**NUMBER:** 07-001-10

**GROUP:** Cooling

Belt Chirp When Steering Wheel Is At Full Lock With Engine RPM At Idle

2010	(KA)	Nitro
2010	(KK)	Liberty
2010	(WK)	Grand Cherokee
2010	(XK)	Commander

**Fig. 1 DRIVE BELT TENSIONER**

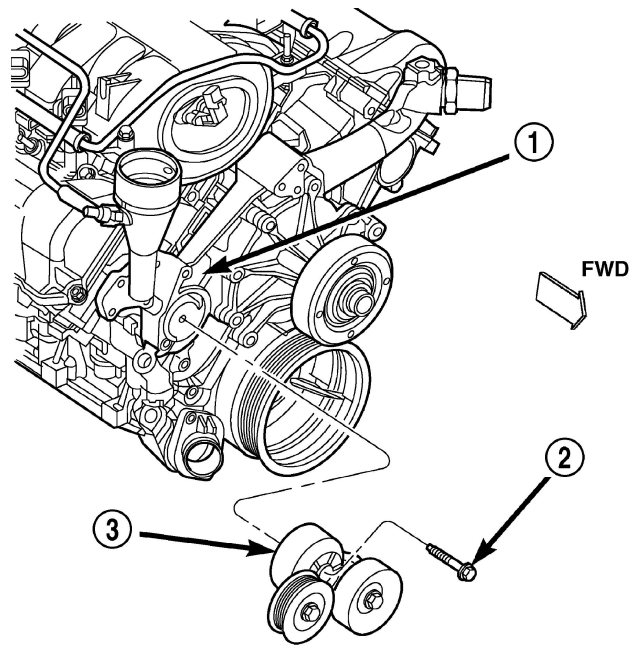
Some customers may experience a belt chirp sound. This sound will be noticeable when the steering wheel is in a full lock condition (right or left) and the engine RPM is at idle. This sound will go away once the RPM is increased.

1. Open hood.
2. Read part number on the top front face of the belt tensioner (Fig. 1).

- 
- 3. Is the part number 53030958AE?
    - a. Yes >>> Further diagnosis in required.
    - b. No >>> Replace drive belt tensioner (p/n 53030958AE)

Qty.	Part No.	Description
1	53030958AE	Tensioner, Drive Belt

- 1 - TIMING CHAIN COVER
- 2 - BOLT TORQUE TO 41 N·m (30 FT LBS)
- 3 - DRIVE BELT TENSIONER
